**Hanford Facility RCRA Permit Modification Notification Forms**

**Part V, Operating Unit 25  
PUREX Storage Tunnels**

Replace the following engineering drawings in Chapter 11 with the updated engineering drawings. These updates were due to completion of the PUREX Storage Tunnel #2 grouting activities.

Figure 11.14. PUREX Tunnel No. 2 Interim Stabilization Enlarged Site Plan 1, #H-2-837314-1

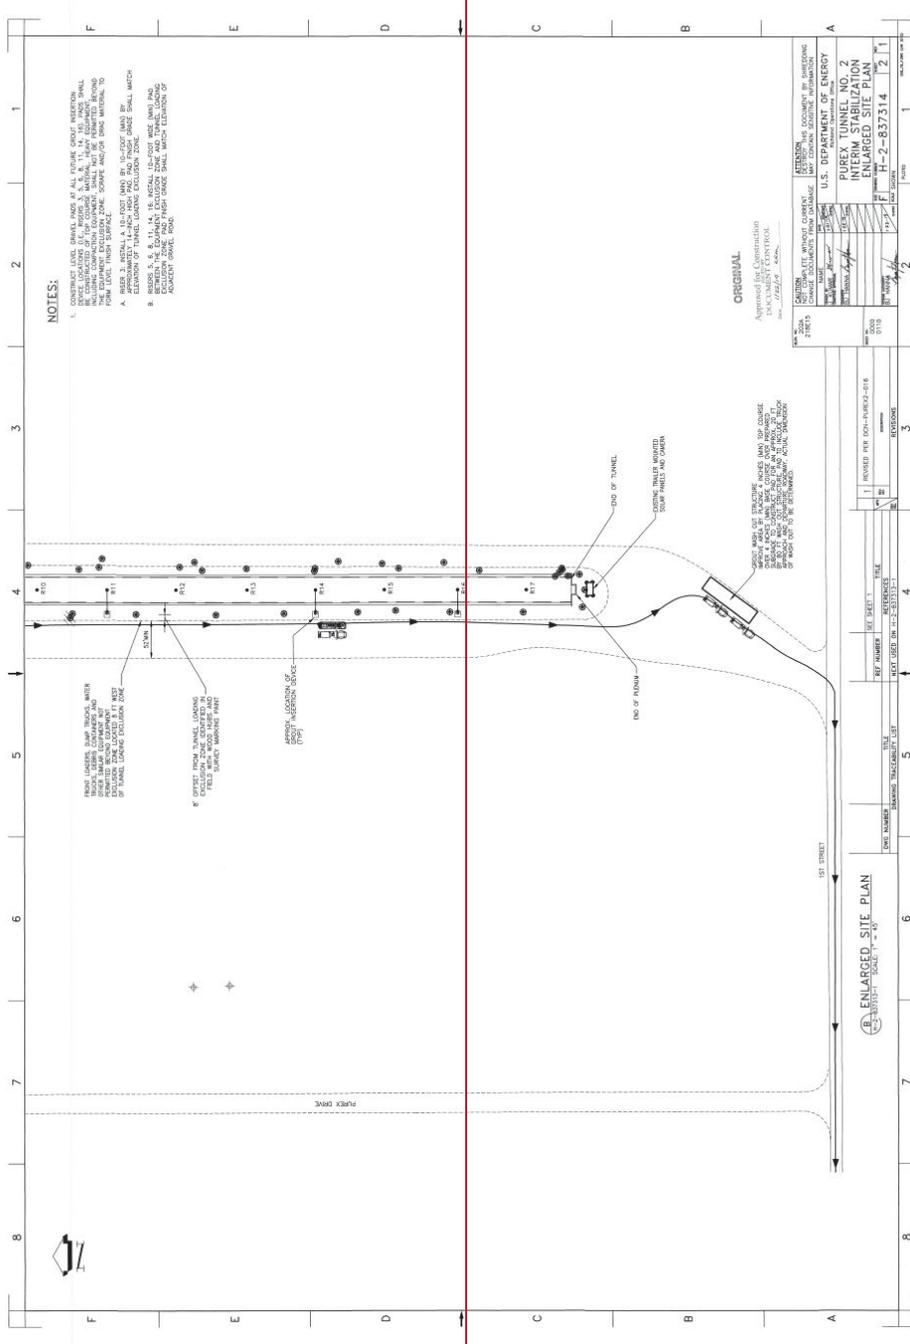
Commented [MPW-C3]: Replace this Figure with the updated Figure.

CHPRC		DESIGN CHANGE NOTICE	
BASE DOC. NO. H-2-837314	SH/PG 1	REV. 1	PAGE 9 of 27
		DCN- PUREX2-019

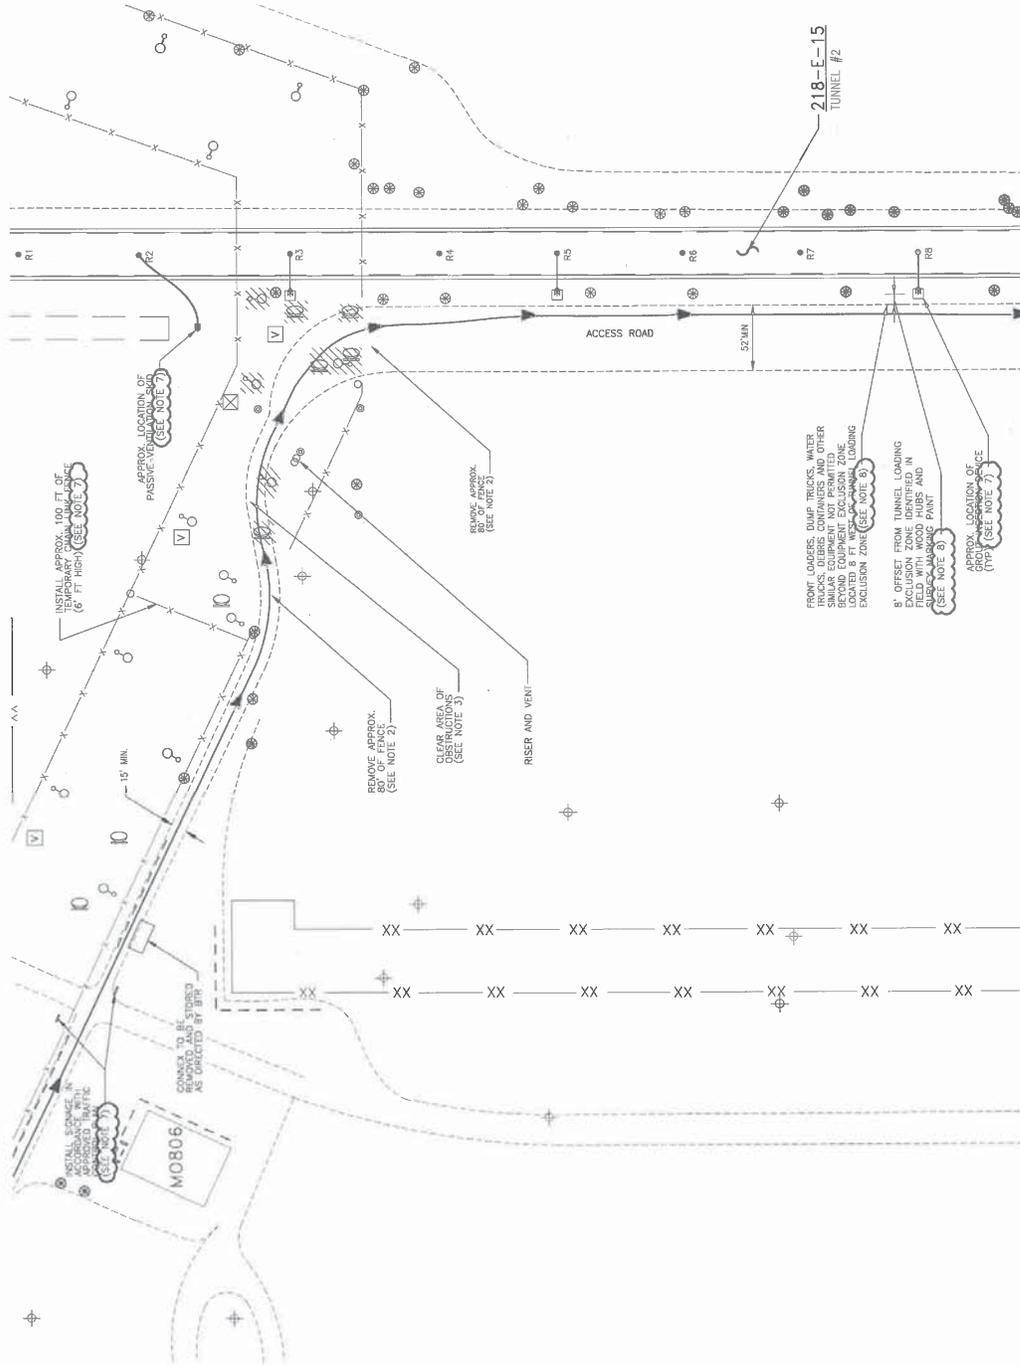
(UPON COMPLETION OF GROUTING ACTIVITIES, REMOVE ADAPTER, CUT OR DRIVE WEDGE ANCHORS FLUSH WITH CONCRETE AND REINSTALL STEEL PLUG.)

<b>CHPRC</b>		<b>DESIGN CHANGE NOTICE</b>	
BASE DOC. NO. H-2-8.37314	SH/PG 2	REV. 1	PAGE 13 of 27
		DCN- PUREX2-019

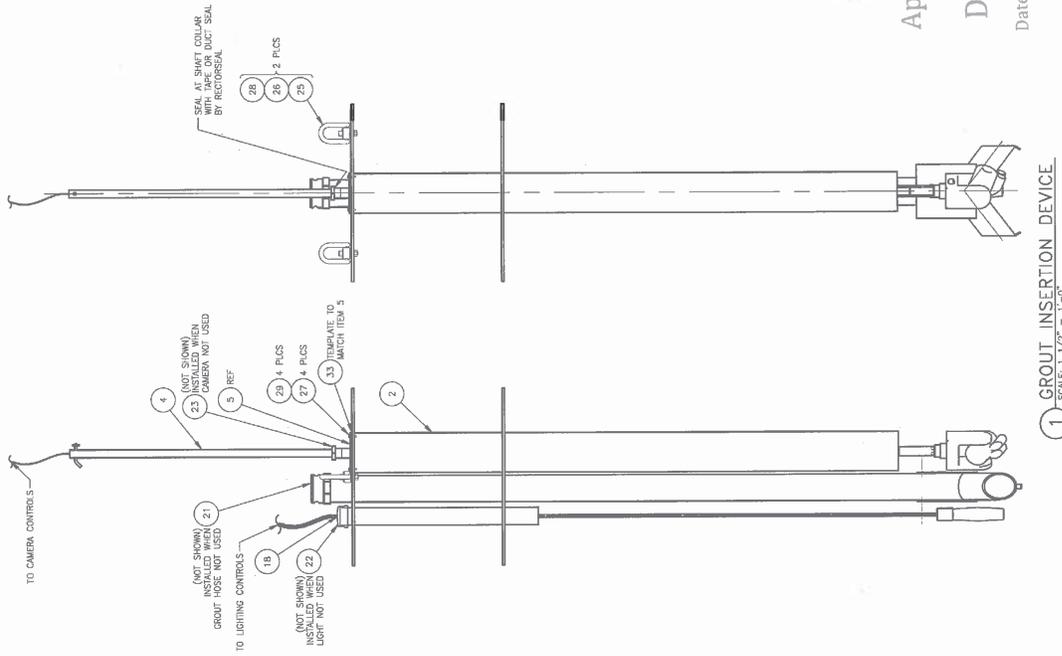
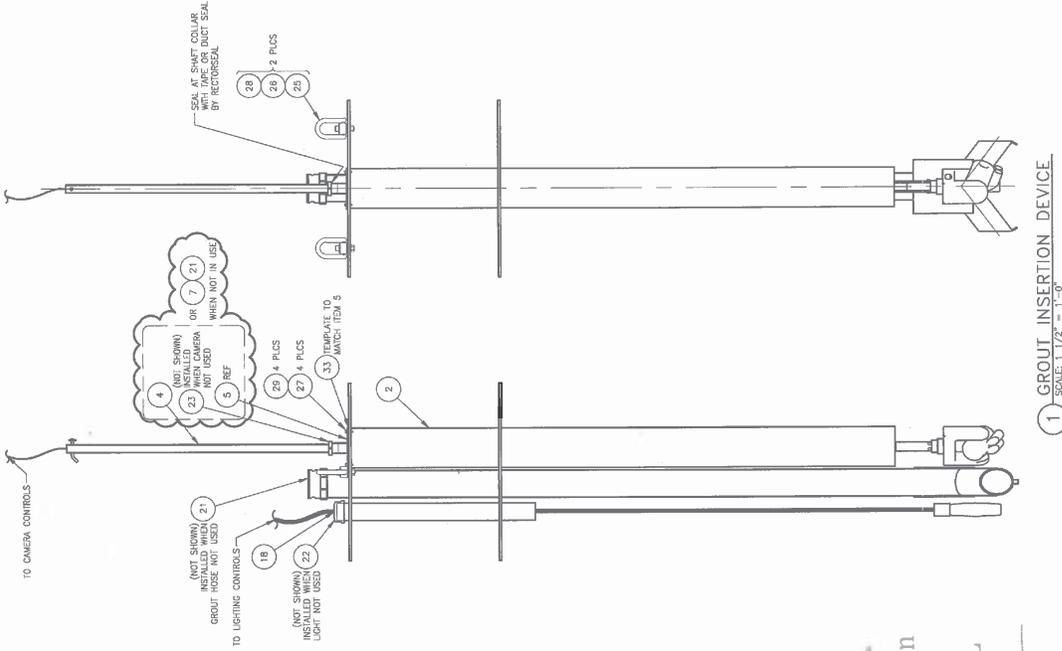
WAS:

IS:

<b>CHPRC</b>		DESIGN CHANGE NOTICE
BASE DOC. NO. H-2-837317	SH/PG 1	REV. 1
		DCN - PUREX2-019
		PAGE 21 of 27

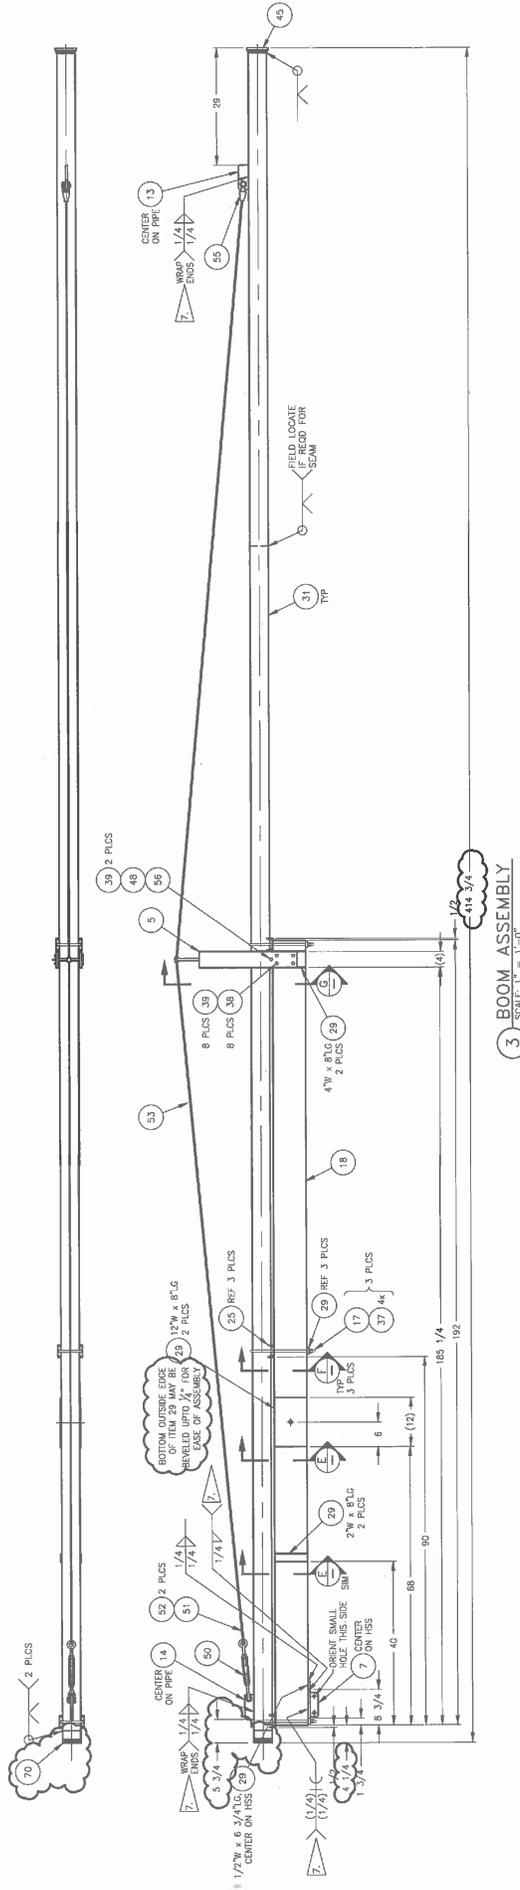
**DRAFTING NOTE:**  
**MOVE REAR CROSS TIE (ITEM 4) TO SHEET 3.**
